PROPOSED MIXED-USE RESIDENTIAL-COMMERCIAL DEVELOPMENT, 3130 WOODROFFE AVENUE CITY OF OTTAWA

FINAL REPORT SEPTEMBER 13, 2022

This report represents the final report, incorporating each step of the 4-step TIA process. Appendix "J" presents a response to the comments provided by City staff on the Step 4 Forecasting report along with references indicating where within this document the comments have been addressed.

APPENDIX C: SITE PLAN

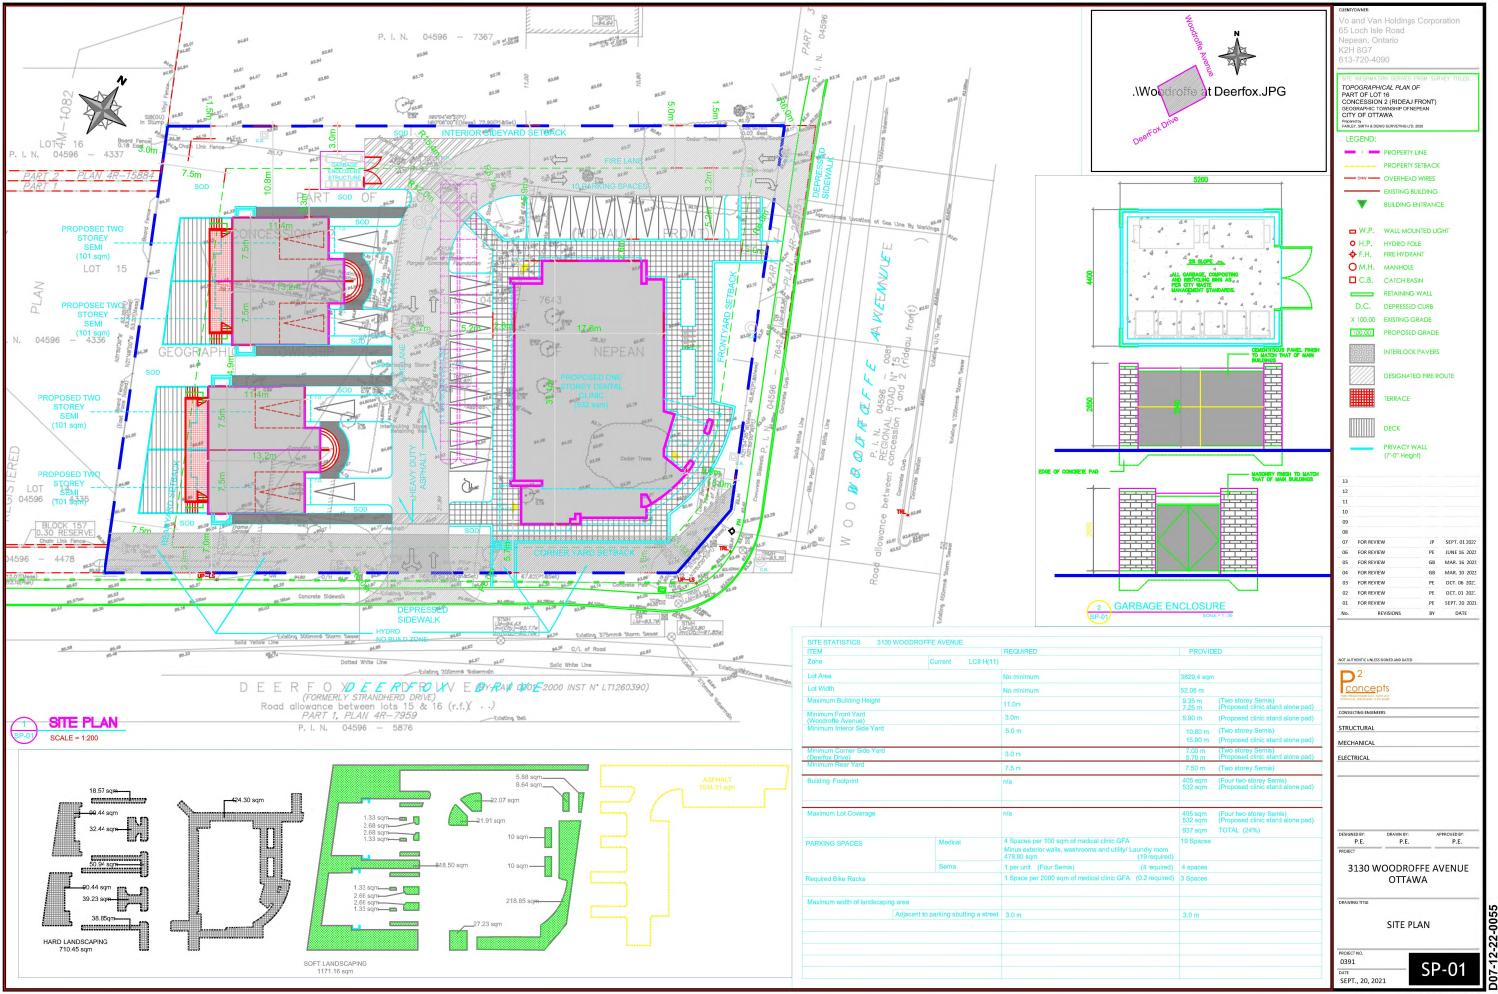
- GC-2: Deer Fox Drive is designated as a collector road within the City's Official Plan with a ROW protection limit of 24.0 metres. The ROW protection limit and the offset distance (12.0 metres) are to be dimensioned from the existing centerline of pavement and shown on the drawings. The Certified Ontario Land Surveyor is to confirm the ROW protected limits and any portion that may fall within the private property to be conveyed to the City.

- GC-4: Woodroffe Avenue is designated as an arterial road within the City's Official Plan with a ROW protection limit of 34.5 to 57.0 metres. Subject to unequal widening outlined in Woodroffe Avenue ESR. The Certified Ontario Land Surveyor is to confirm the ROW protected limits and any portion that may fall within the private property to be conveyed to the City.

- GC-6: All underground and above ground building footprints and permanent walls need to be shown on the plan to confirm that any permanent structure does not extend either above or below into the sight triangles and/or future road widening protection limits.

- Response: The architect will be notified as per Section 4.5. Any appropriate changes will be made.
- GC-7: Permanent structures such as curbing, stairs, retaining walls, and underground parking foundation also bicycle parking racks are not to extend into the City's right-of-way limits.

- *Response*: Architect will be notified as per Section 4.5. The ROW protection limits will be illustrated on the drawings,
- GC-3: ROW interpretation Land for a road widening will be taken equally from both sides of a road, measured from the centreline in existence at the time of the widening if required by the City. The centreline is a line running down the middle of a road surface, equidistant from both edges of the pavement. In determining the centreline, paved shoulders, bus lay-bys, auxiliary lanes, turning lanes and other special circumstances are not included in the road surface.

- Response: Section 2.1.3 addresses this. The Woodroffe Avenue ESR was reviewed, which specifies that a 37.5m wide ROW is to be protected on Woodroffe Avenue between Rideaucrest-to-Strandherd which includes the Deerfox Drive intersection. The appropriate ROW protection limits will be shown on the drawings. On April 22nd, 2022 an e-mail from Wally Dubyk expressed his concurrence that the protected ROW of 37.5 metres and sight triangle dimensions may have already been provided. He requested that the proponent submit a copy of the surveyed property parcel to the City as part of the Site Plan Agreement. This was communicated to the proponent.

- *Response*: The architect will be notified as per Section 4.5. The architect is to confirm that these elements do not extend ROW limits
- GC-8: The consultant should review the sight distance to the access and any obstructions that may hinder the view of the driver.
